**MUNICIPAL CORPORATION
KARACHI.**

Re: Plot No. 103. M.M.6.

AMENDED
PLAN SHOWING PROPOSED ADDITIONS & ALTERATIONS ON PLOT N: 103. SHEET N: M.M.6.
MACHIT MIANEE QUARTER
Scale 8 1/2" = 1" = 10' INCH

With reference to your application dated 13th February 1939 with a plan for the proposed buildings/additions and alterations on plot No. 103 Survey Sheet No. M.M.6, Machi Meani Quarter, I have to request you to comply with the following requirements:—

PLAN SHOWING PROPOSED ADDITIONS & ALTERATIONS ON PLOT No. 103. SHEET No. M M 6.

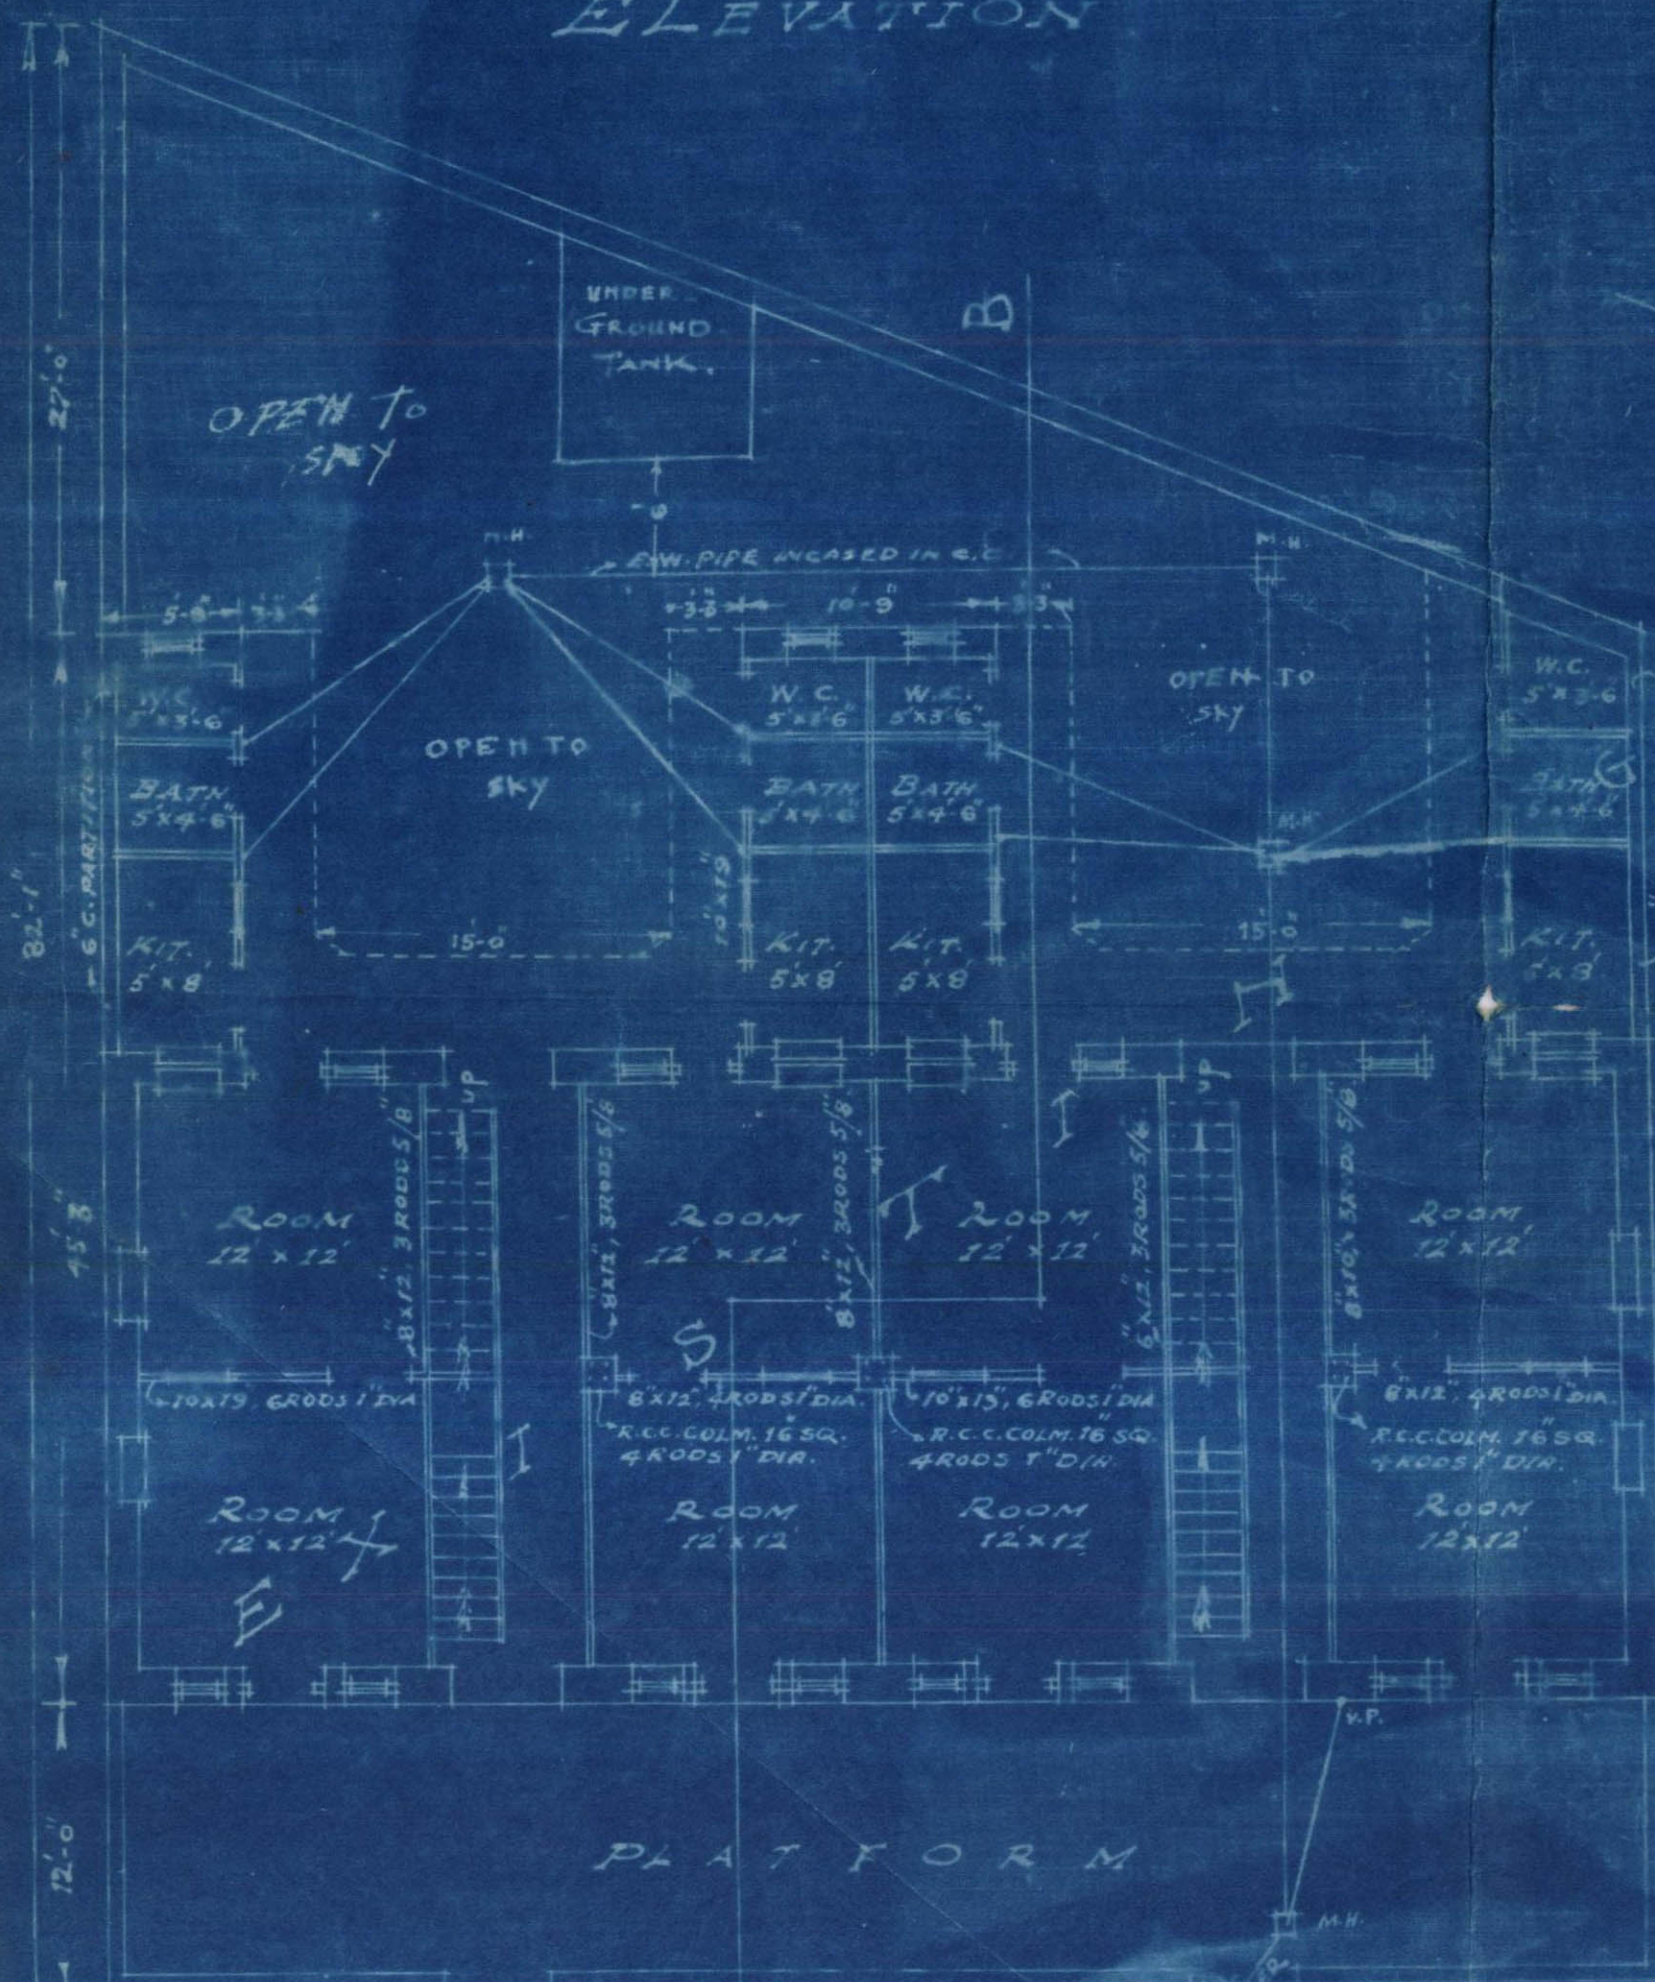
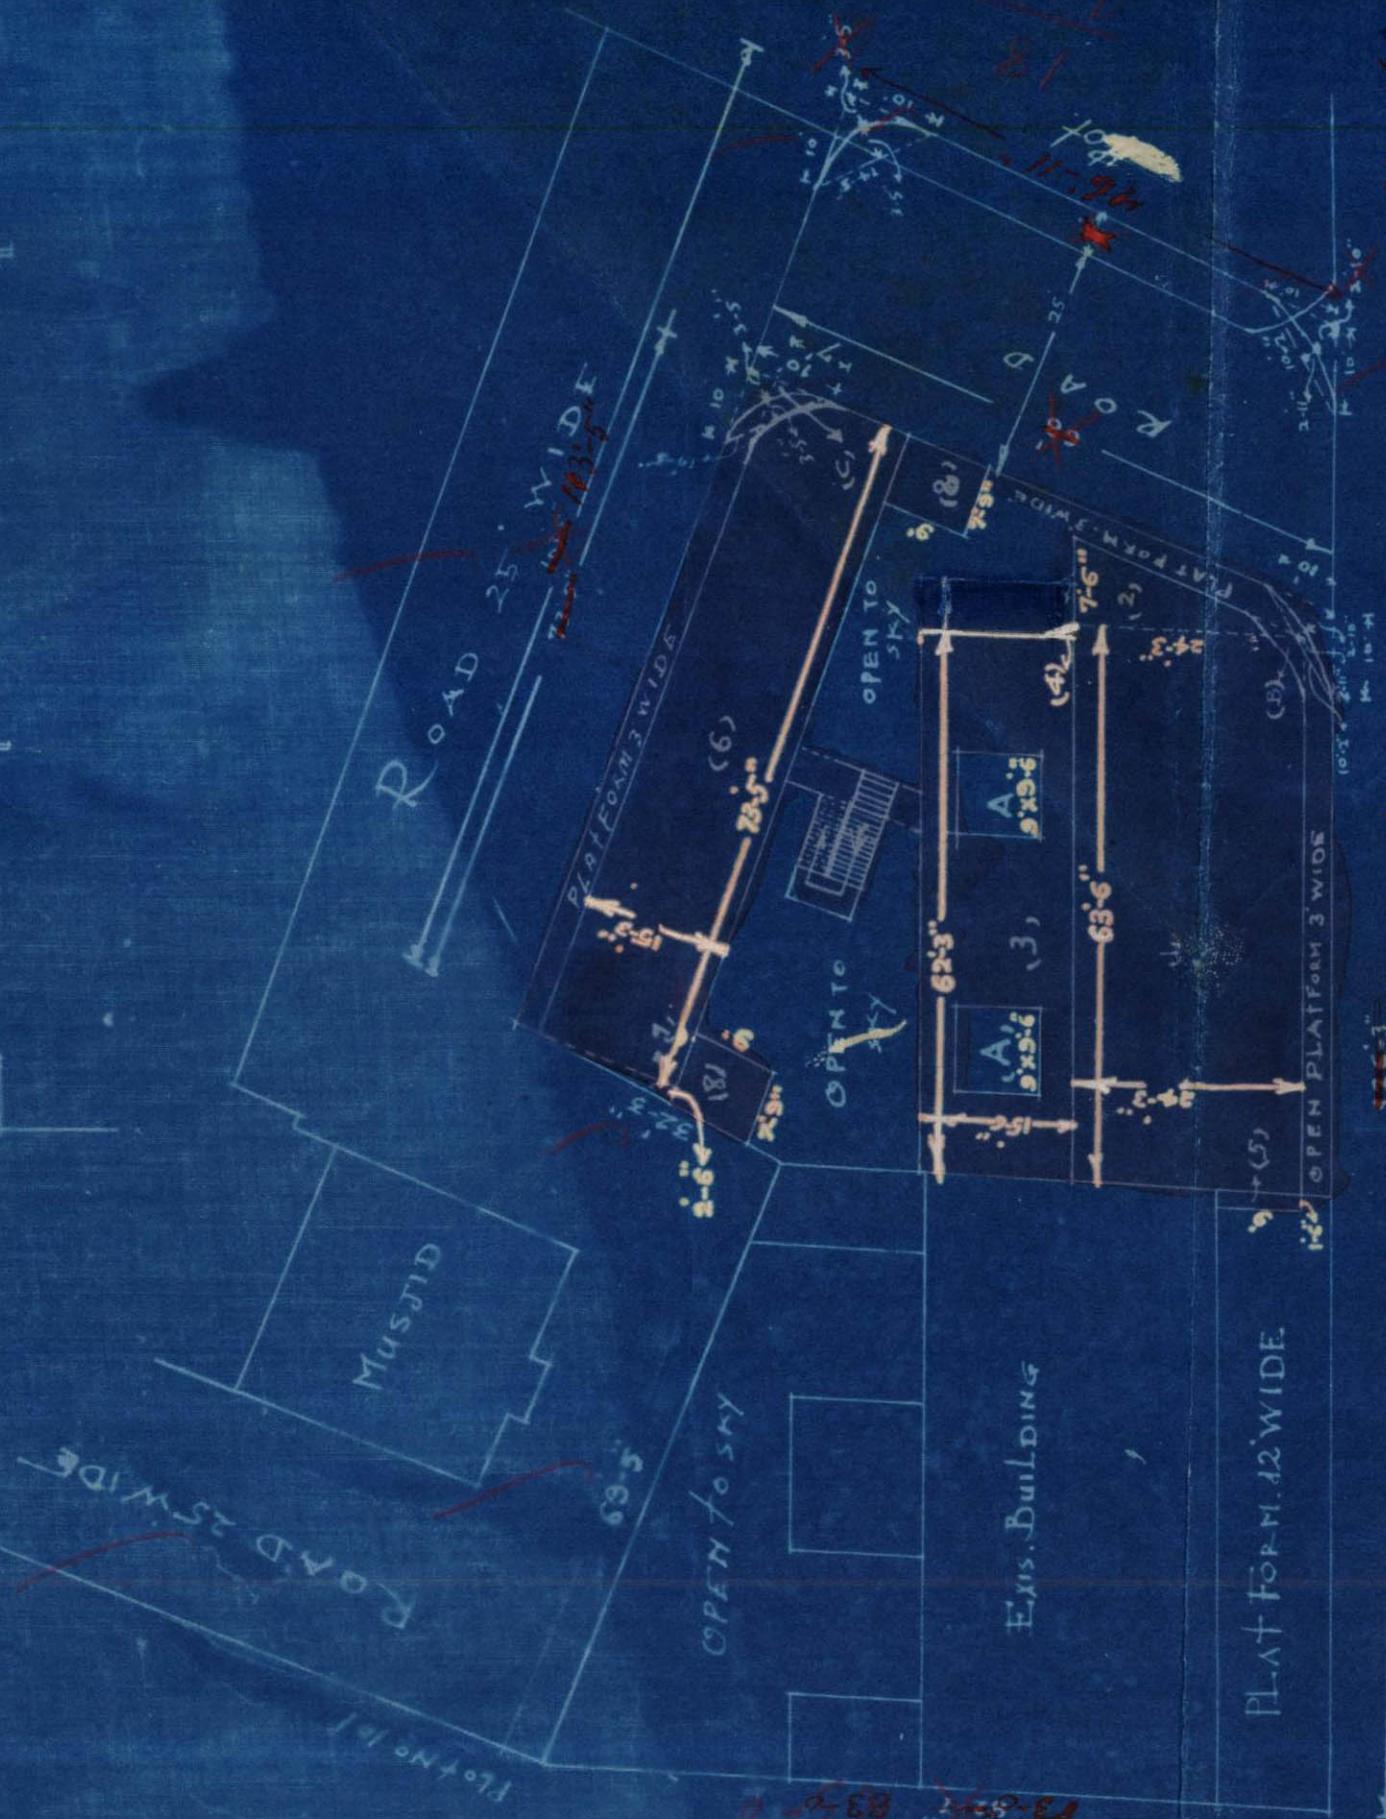
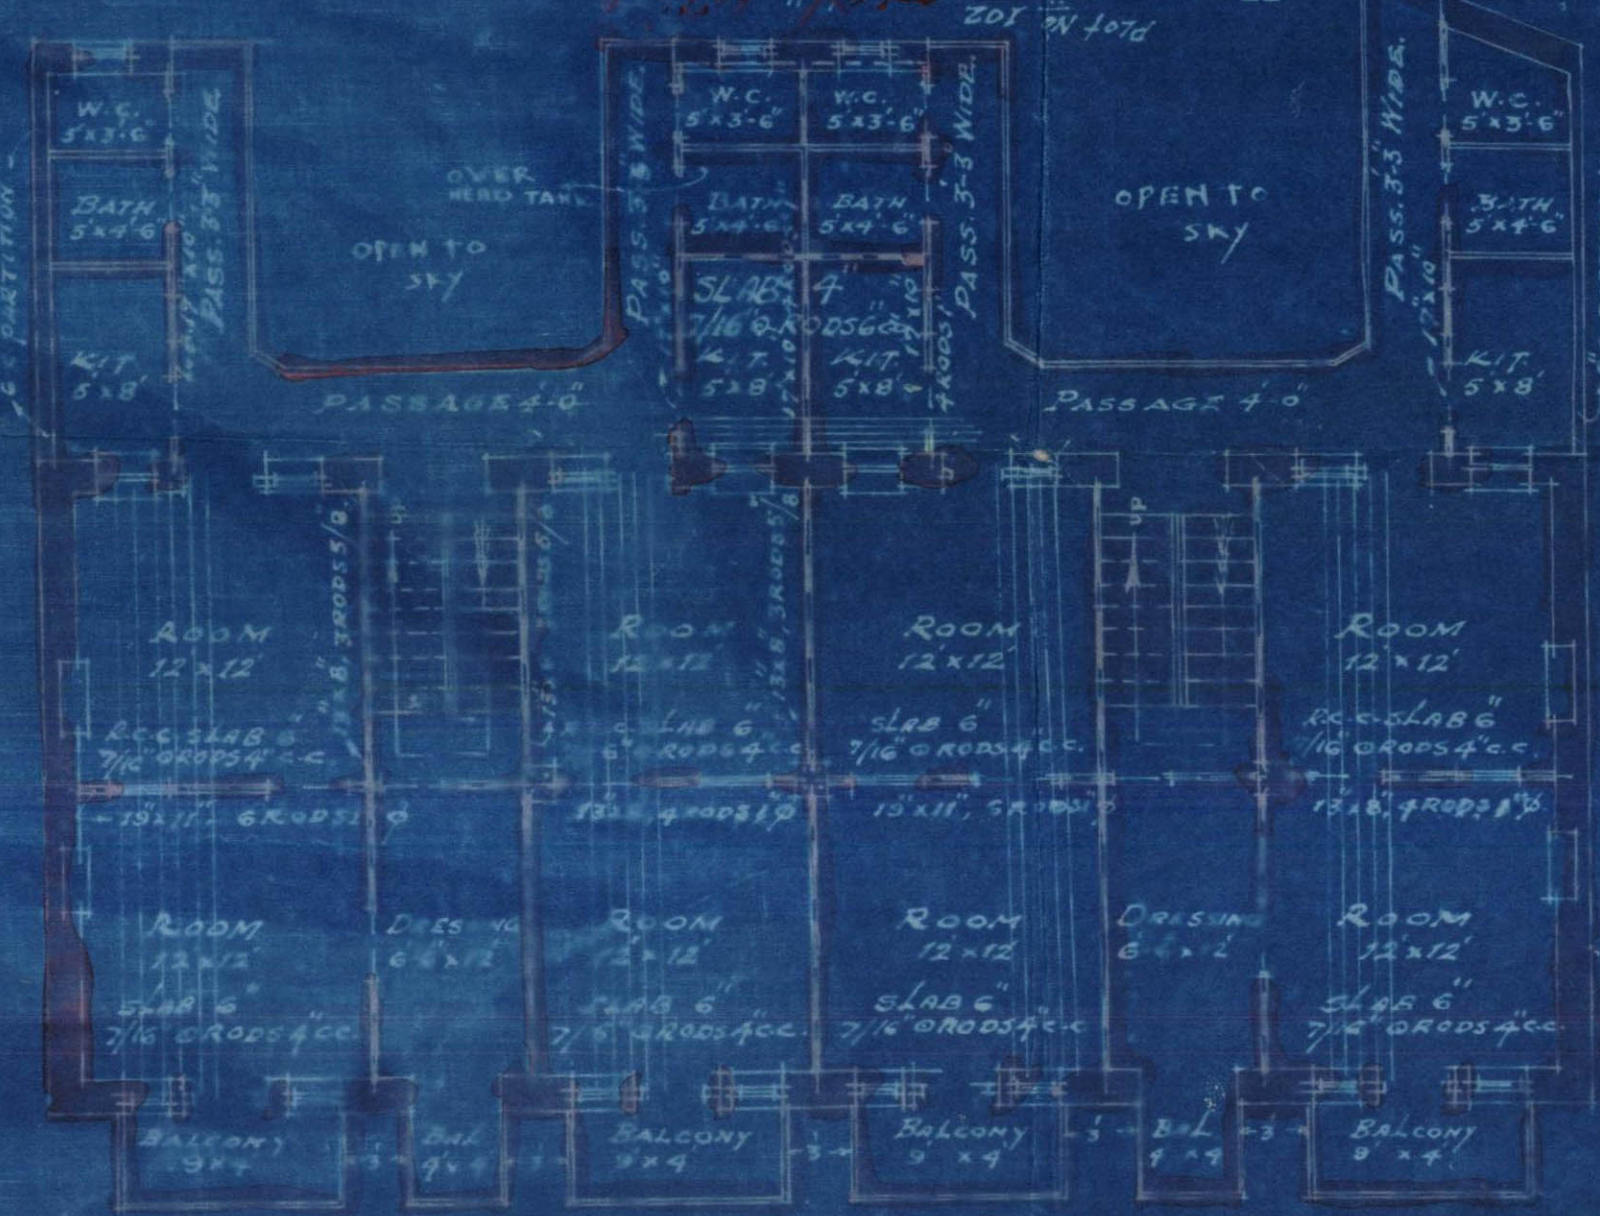
Note:-
Plan approved subject to
confining the built-up area
to 2/3 only of net area.
